FILE P.I. No. 0007643, Cobb County
CSHPP-0007-00(643)
Pedestrian Bridge on Spring Road over CSX Railroad
In the City of Smyrna

SUBJECT APPROVED PROJECT CONCEPT REPORT

Pedestrian Bridge on Spring Road over the CSX Railroad in Smyrna

Concept Team Meeting Minutes

LOCATION SKETCH

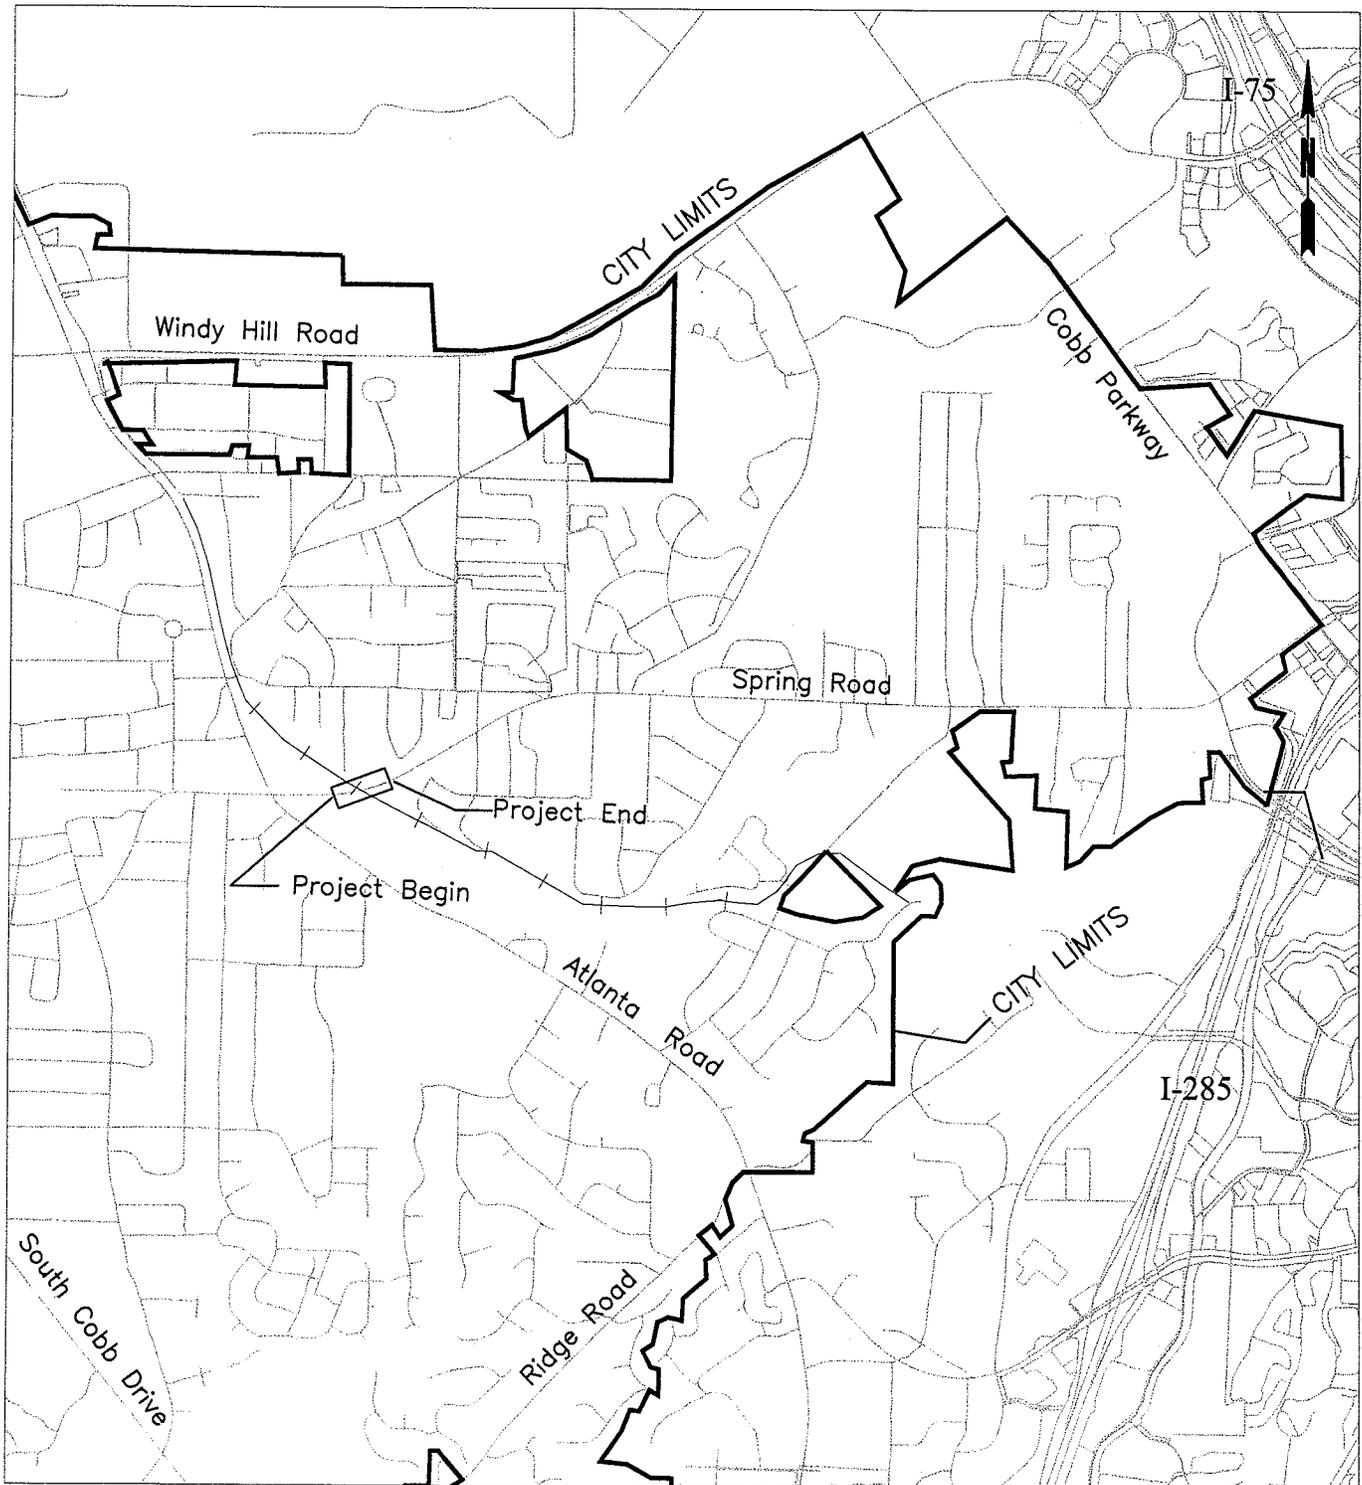
- Page 2, Location Sketch – Revise the Interstate symbols so that they are legible. Add the Smyrna City Limits. Enlarge the font.
- Page 3, Need and Purpose – Include the Smyrna Project numbers and a brief description of the trail projects proposed east and west of pedestrian bridge project. Delete the sentence that begins, "Although there is..."

TYPICAL SIDEWALK SECTION @ BRIDGE APPROACH

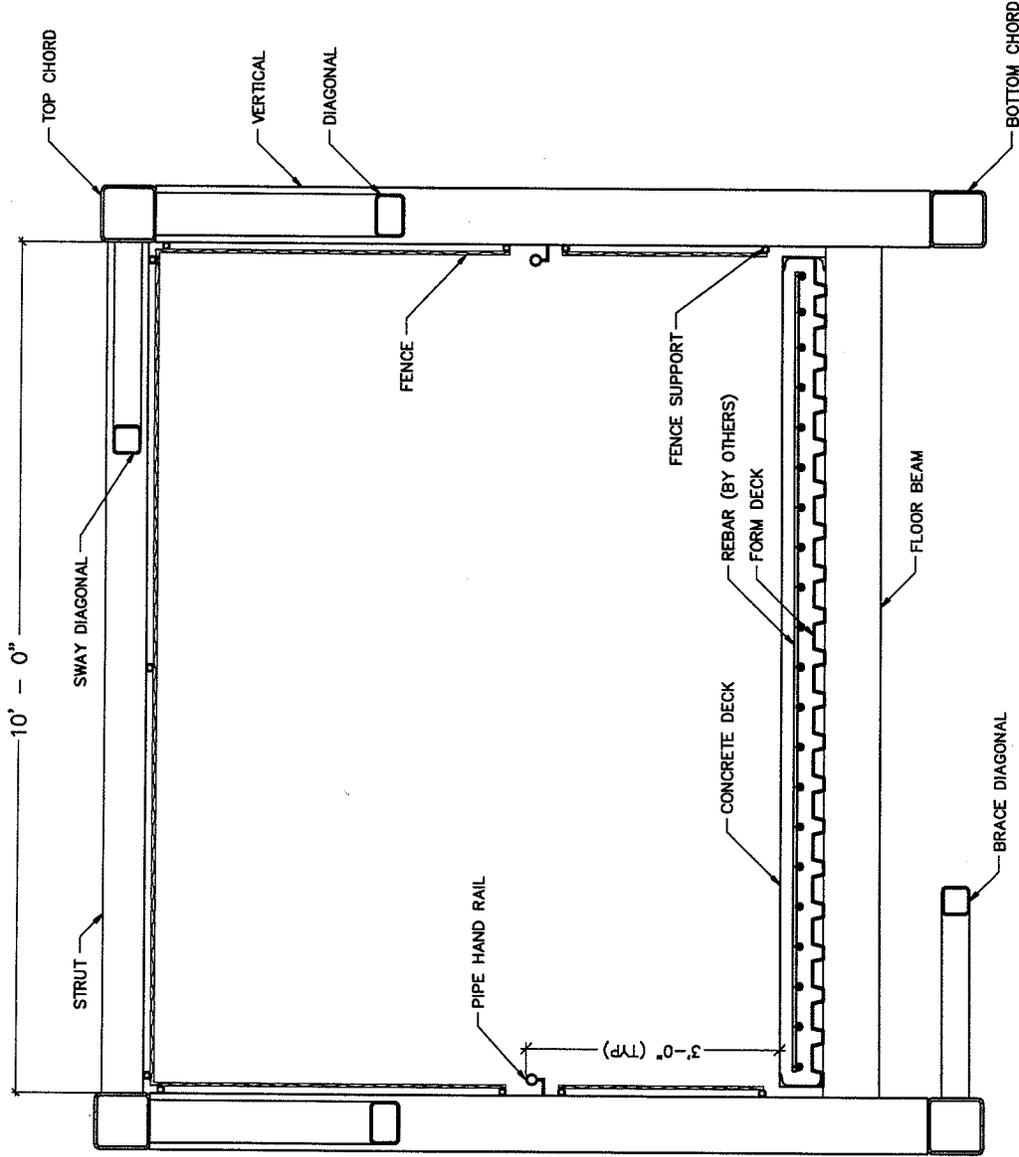
- Typical Section – Add the minimum and maximum height of the retaining wall. It should be a 1 foot "hardscape" strip.
- L&D Approval – Mike Lobdell's phone number is (770) 986-1257.
